July 15, 2016

**BOARD OF COUNTY COMMISSIONERS
ORANGE COUNTY, FLORIDA**

**ADDENDUM NO. 3 / IFB NO. Y16-776-PH
INTERNATIONAL DRIVE POTABLE WATER BOOSTER PUMP STATION**

OCU FILE NO.: 74251	SCALE: AS NOTED
DESIGNED BY: JAB	DRAWING NO.:
DRAWN BY: LDM	A4.0
CHECKED BY: JAB	SHEET: 24 OF 49
CADD FILE: 028246-ARCHITECTURE

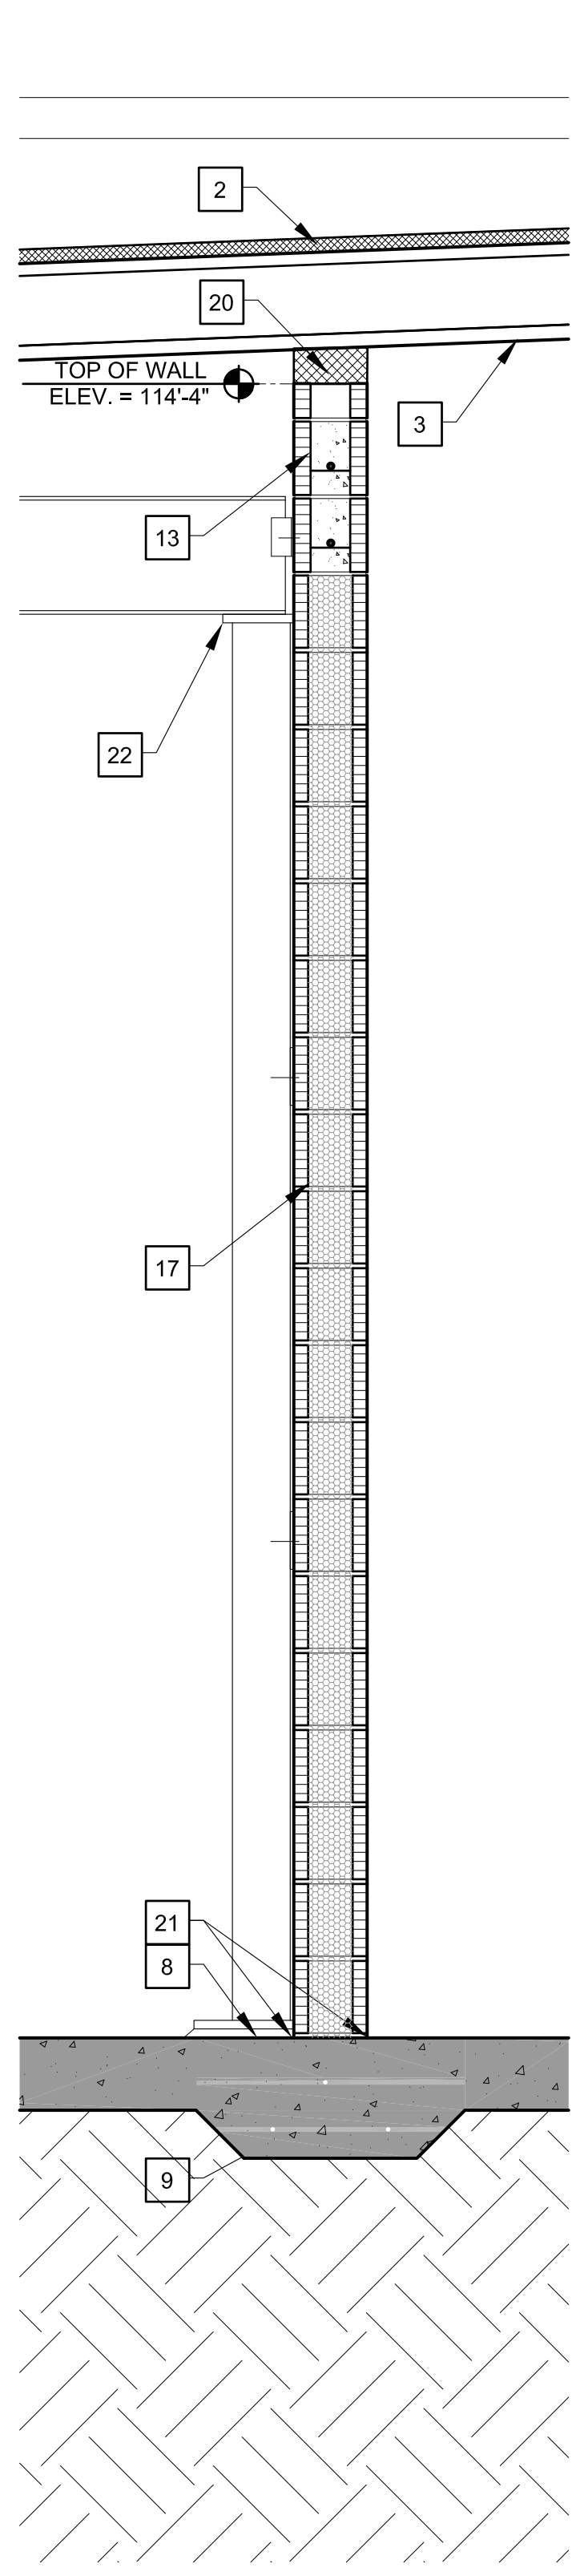
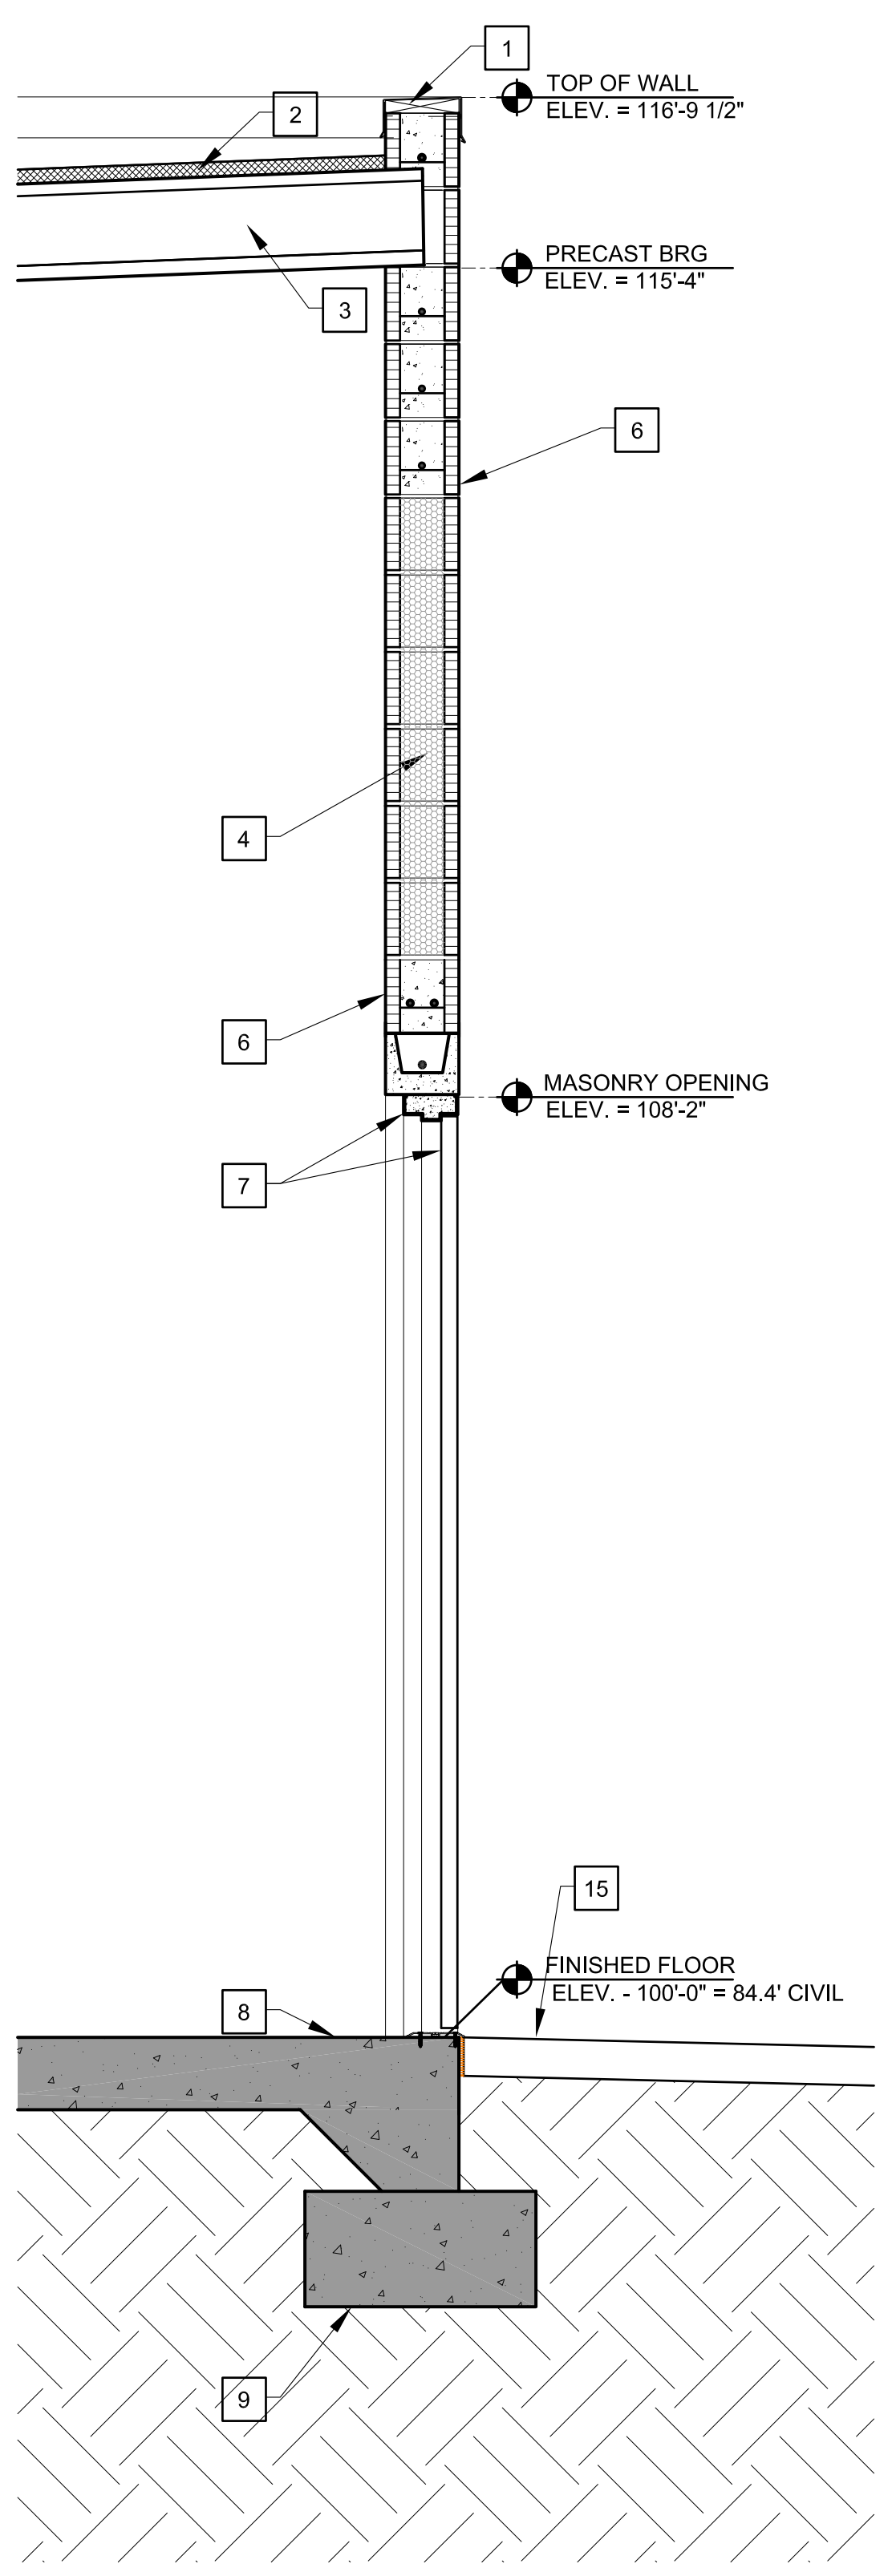
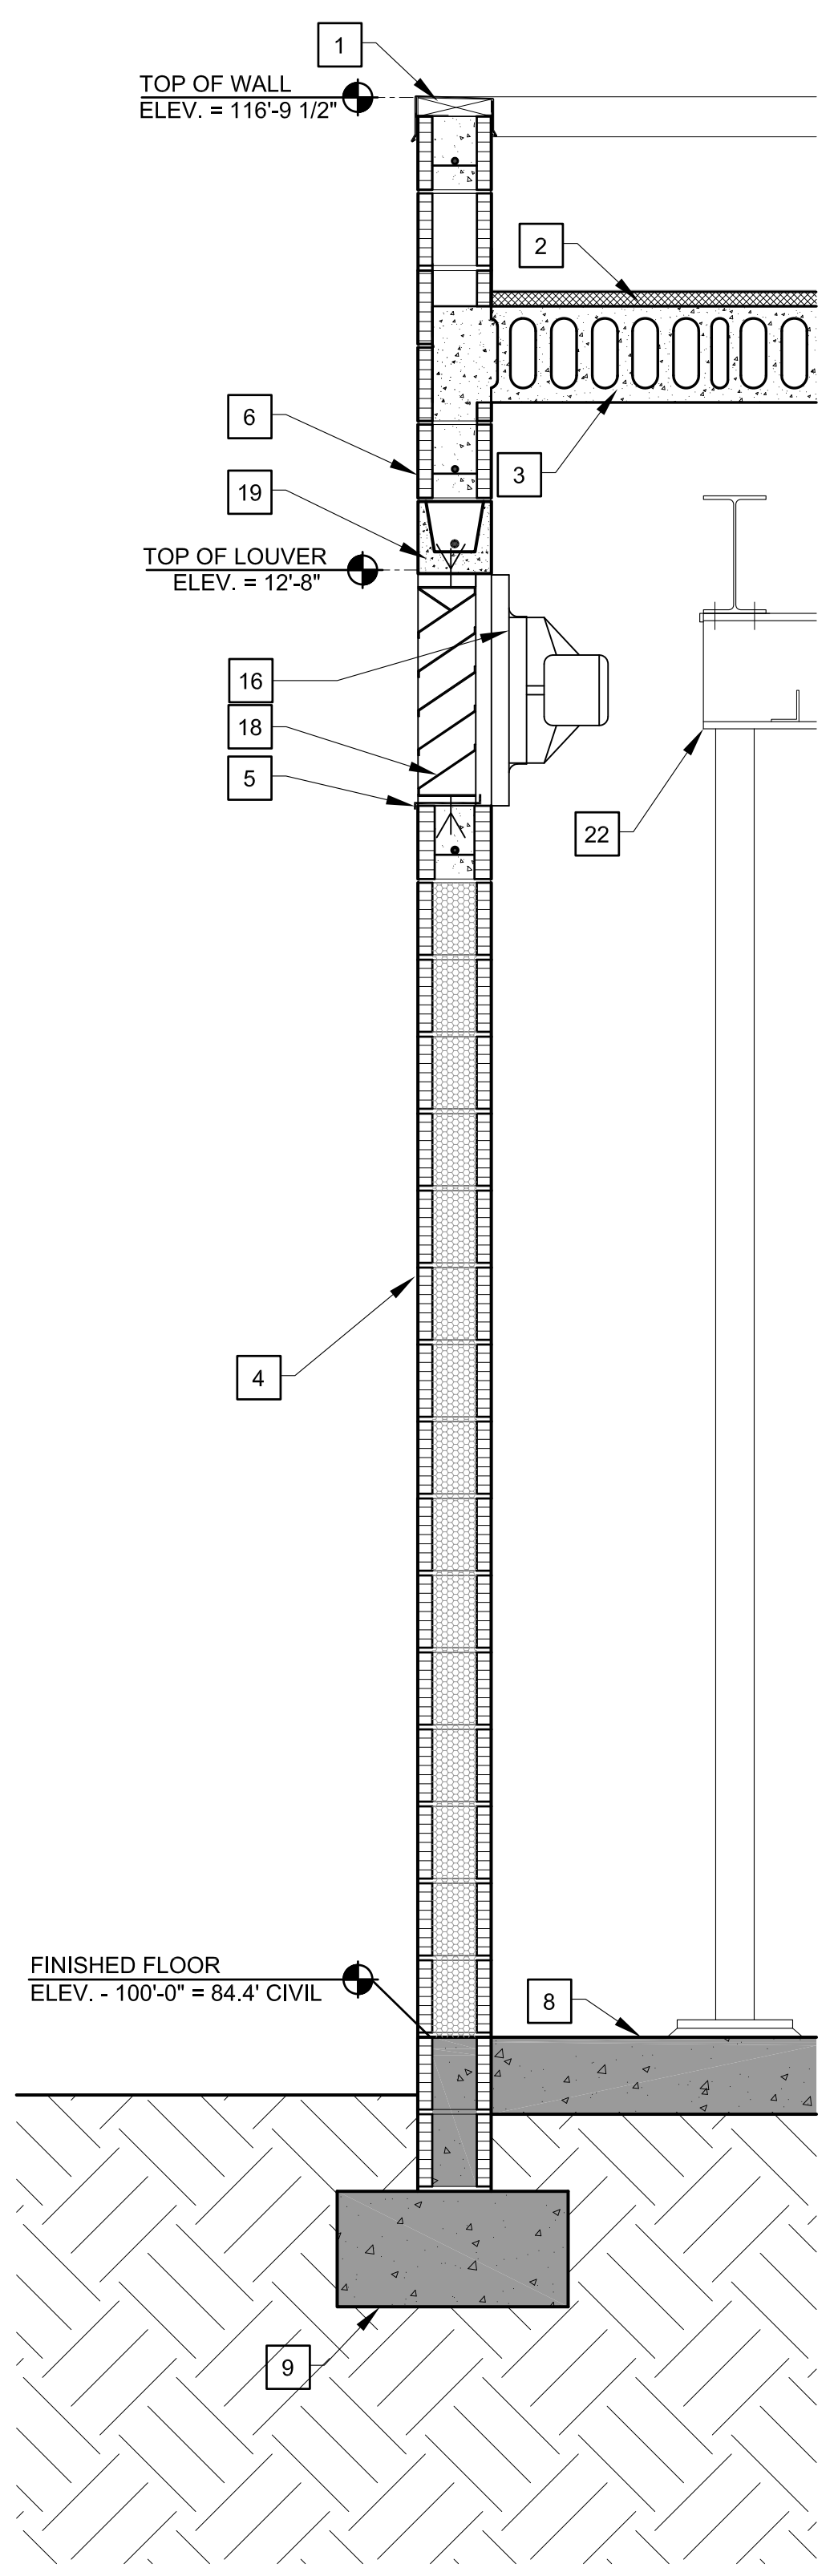
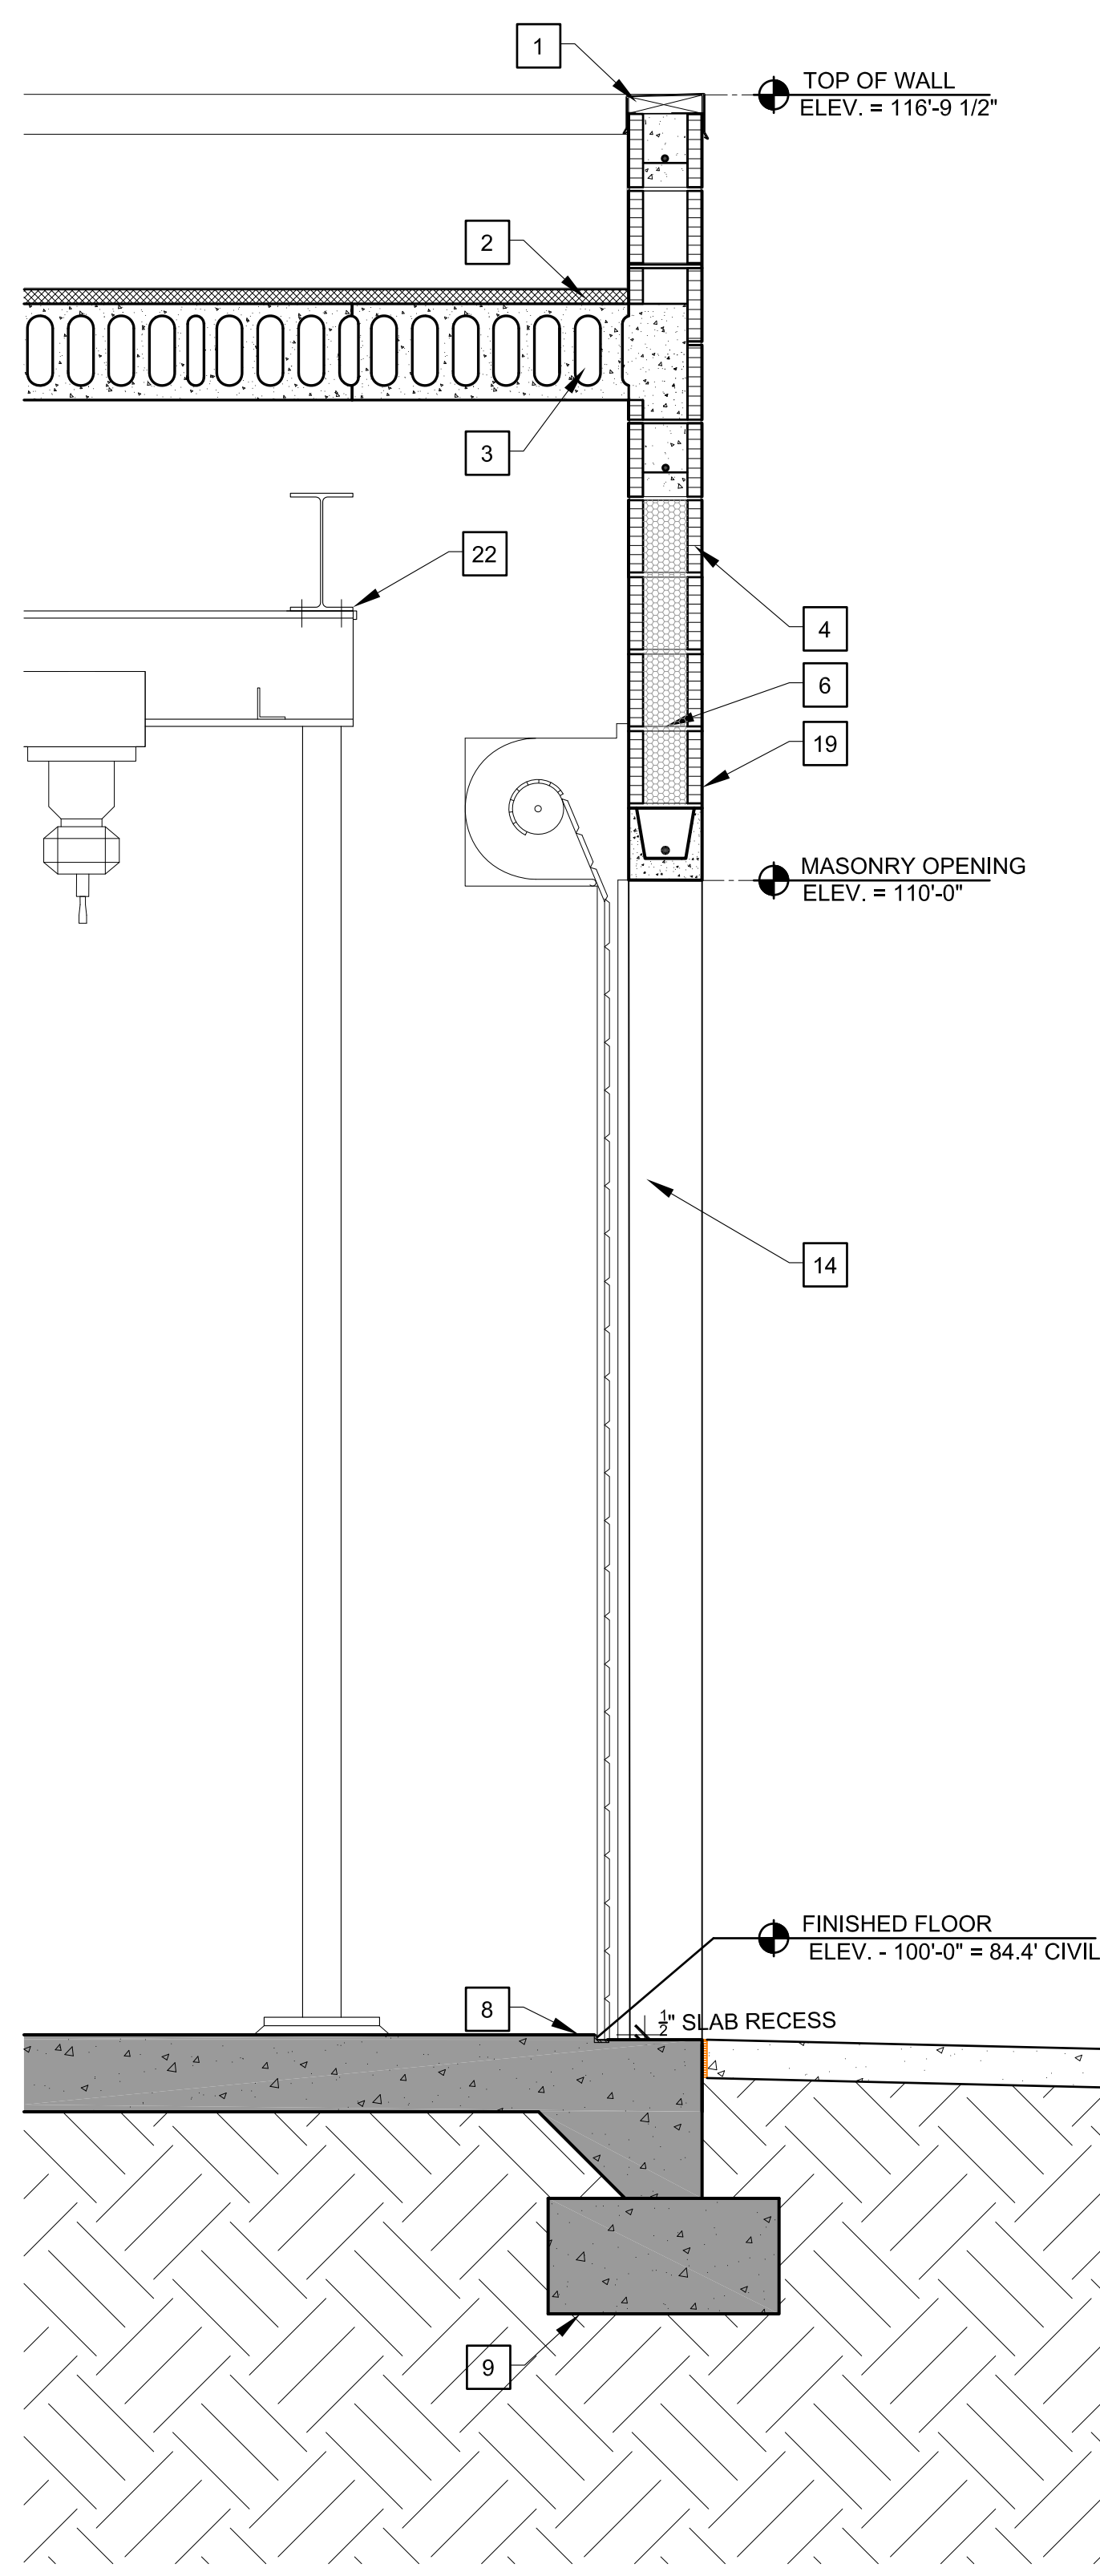
11. Q: The following documents is missing from the Plan Set – Drawing A4.0 – Wall Section (page 24).

A: See Drawing A4.0, attached to Addendum No. 3.

Amend: Delete duplicate Drawing H-04 and insert attached Drawing A4.0 in its place.
